Proposed Great Wolf Lodge, Chesterton, Bicester

Highways and Transport Evidence on behalf of Great Lakes UK Limited

OCC Response September 2020

### OXFORDSHIRE COUNTY COUNCIL'S PRE APPLICATION ADVICE ON THE RESPONSE TO CONSULTATION ON THE FOLLOWING DEVELOPMENT PROPOSAL

Drawing no. 1803047-17 Rev. C

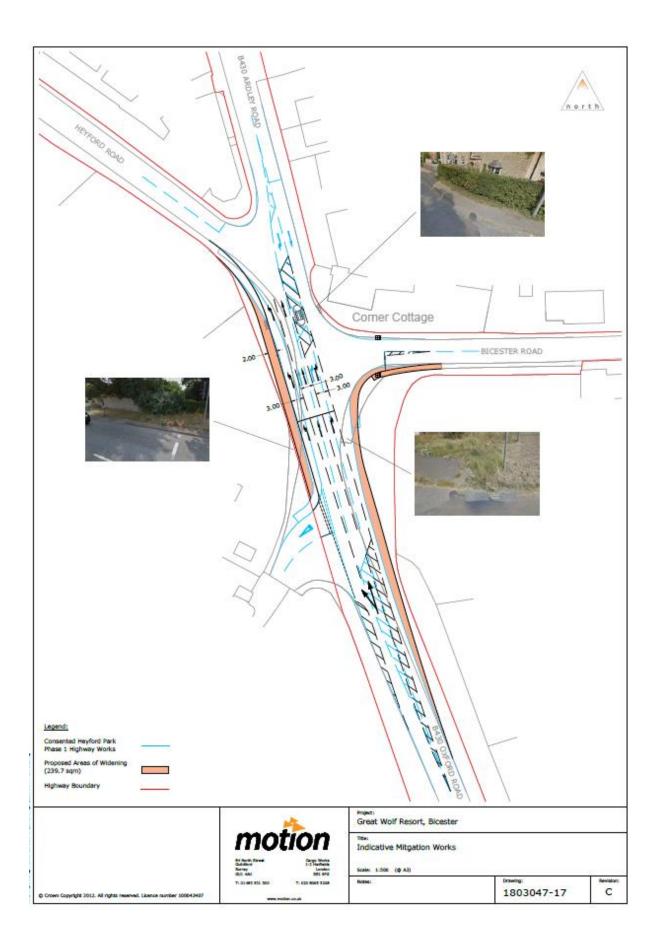
Motion have separately supplied a version of the Indicative Mitigation Works drawing (Rev. C) that is marked up to illustrate the areas of proposed widening over and above the Heyford Park scheme (see Appendix A). This shows further encroachment into the south-east verge

and the footway being positioned up against the boundary wall on the west side, with nearly all the grassed verge being removed on this side.

Whilst it is agreed that the proposed scheme falls entirely within the highway boundary, because of the widening which brings the carriageway closer to properties and reduces verges, the environmental impacts would need to be considered before such a scheme could be agreed or implemented. The scheme has potential impacts on air quality, noise and vibration, and heritage. Consequently, the scheme may not be considered to be deliverable if the environmental impacts are not acceptable.

Proposed Mitigation Works – B430/B4030 Middleton Stoney

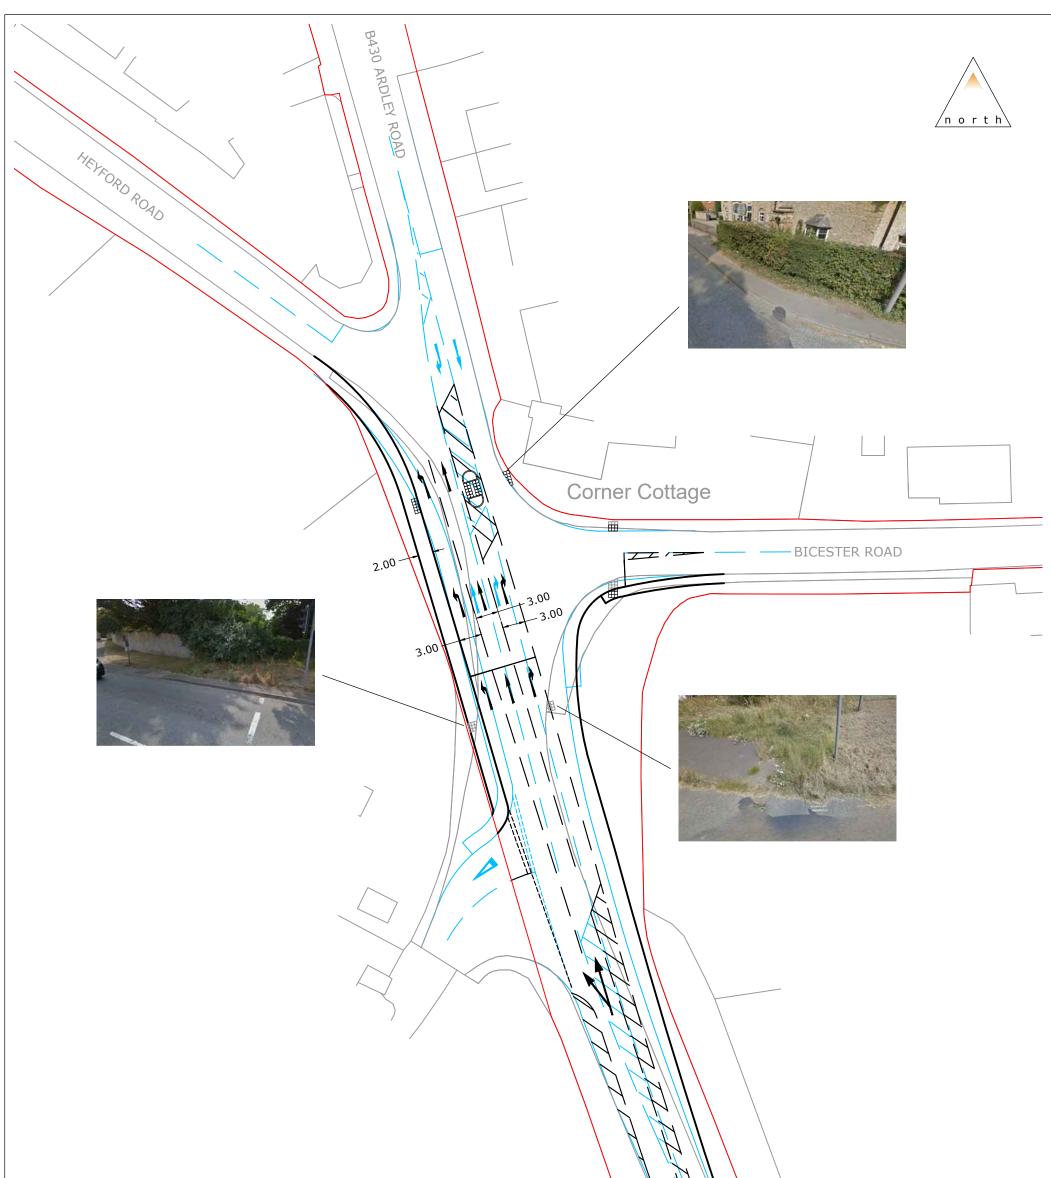
The second Motion analysis is modelled on the layout proposal as shown in drg. no. 1803047-17 Rev. B, with the Great Wolf Resort peak hour generated traffic being added to the flows.

The comparative outputs show that, despite the expansion of the junction to include a left turn only lane from the northbound B430, the performance of the junction remains over the theoretical capacity and is marginally worse with the Great Wolf generated traffic and mitigation. The Degree of Saturation (DoS) increases by just over 1% on the B430 southbound and B4030 westbound (titled B4030 (east) in the Tables), whilst the Mean Maximum Queue (MMQ) increases by 9% and 8% respectively.

Given the results of the analysis, it is not considered that the proposed Great Wolf mitigation scheme will reliably provide a signalised junction that will alleviate the current severe congestion or will improve upon the consented Heyford Park mitigation scheme.

The proposed layout will necessitate a significant change to the facilities for pedestrians wishing to cross the B430. With the current arrangement, which is largely unaltered in the Heyford Park mitigation scheme, the informal crossing point is behind the stop line for northbound B430 traffic, which means that pedestrians may have to cross between vehicles in a queue (two lanes in the case of Heyford Park mitigation) of stationary vehicles. The proposed Great Wolf mitigation incorporates a pedestrian refuge at the centre of the junction, allowing pedestrians to cross in two stages. However, the waiting area on the east side footway is very narrow, meaning that any waiting pedestrians would be uncomfortably close to passing or turning vehicles, particularly HGVs. Furthermore, the footway to the north is even narrower as the kerbline is particularly close to the highway boundary.

It is appreciated that there is no identifiable pedestrian (or cyclist) crossing point that would accord with current standards. At this stage, OCC are neutral about replacing the existing crossing point with one that allows improved crossing opportunities but has constrained access on one side.

We note that Motion has previously indicated that the above matters can be addressed at Detailed design stage but we are concerned that there is very limited scope to address the above issues in a situation where the mitigation scheme is geometrically constrained.

In particularly, we are concerned that the proposed mitigation does nothing to address the existing footway width problems at the junction. Some of the footway widths are considerably below standard with widths of less than a metre in places. With the introduction of a new pedestrian refuge, pedestrians are encouraged to focus crossing movements at a specific point where the existing footway is at its narrowest. They are then expected to cross uncontrolled during intergreen periods in a situation where larger vehicles may be trying to clear the junction.

The submitted swept paths indicate that there will be instances where large vehicles over-sail the footway areas. In a situation where the footways are already sub-standard, we are concerned that the new layout will put pedestrians at a greater risk.

In relation to the geometry, we have now had a further opportunity to undertake a full review of the preliminary design against the DMRB and note that the design appears to fall short of standards in relation to taper lengths on the approach to the junction while we note that the preliminary design does not yet show the position of the signal poles and heads. We are concerned that the signal poles will be difficult to locate within such a tight geometry and may further reduce the pedestrian footway space that is available.

When the above concerns are taken into account, we are of the view that the proposed mitigation scheme is not sufficiently developed to remove our concerns and we believe that there are constraints that prevent the above concerns being addressed. We are therefore of the view that the development has an unacceptable impact on Highway Safety at the Middleton Stoney junction.

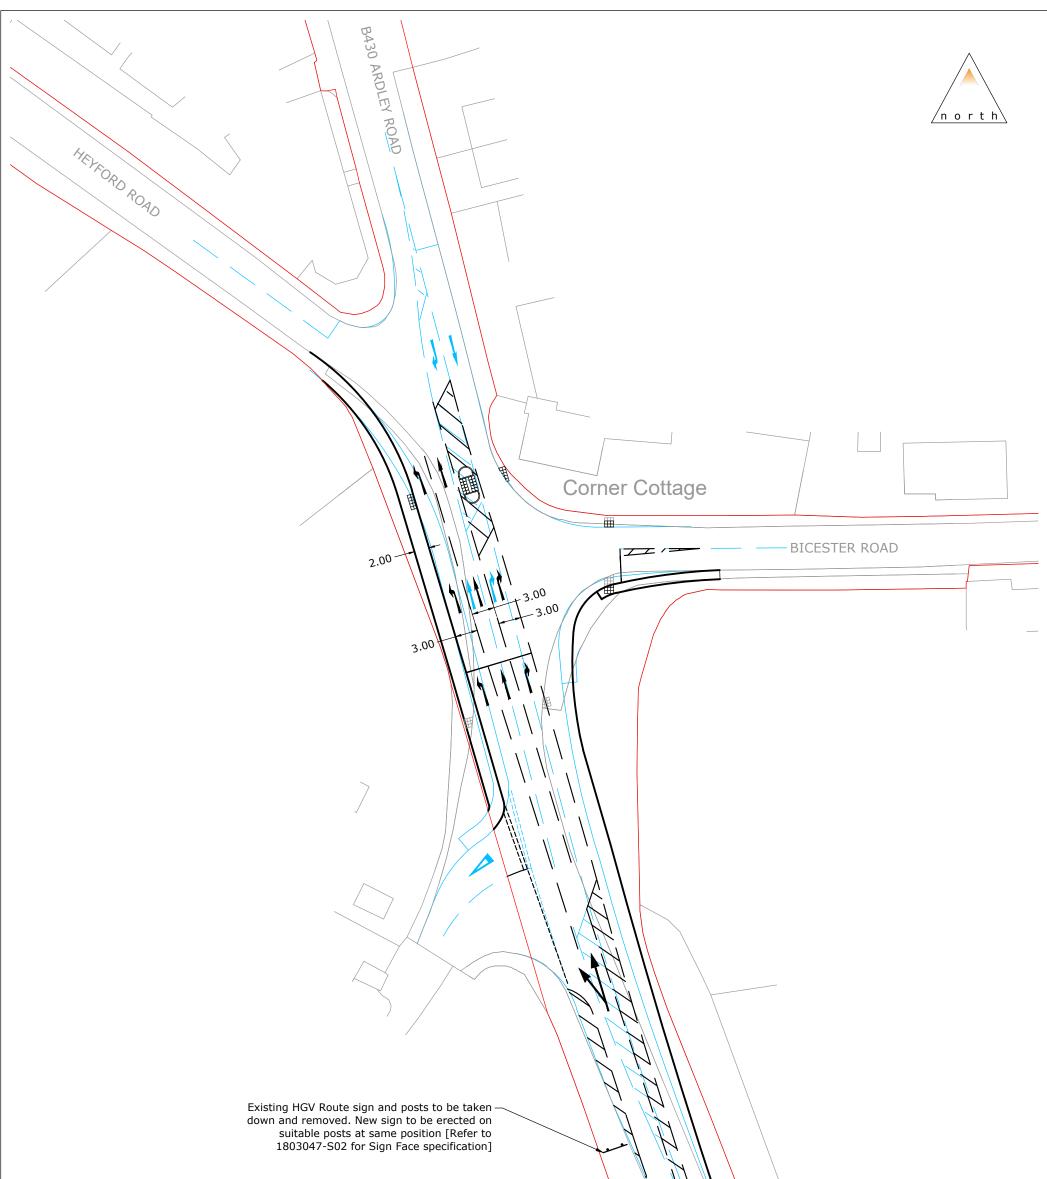
Drawing 1803047-SK13 indicates the location of the proposed sign and a plan view of the sign in position. We would note that a minimum clearance of 450mm will be required from the edge of the sign to the edge of the carriageway.

We would be of the view that the signage proposal appears to be acceptable in principle (subject to detailed design and taking into account signage proposals associated with the Heyford Park Phase 1 mitigation scheme) but we would reserve our position on signage in a situation where we do not accept the current general layout of the mitigation scheme.
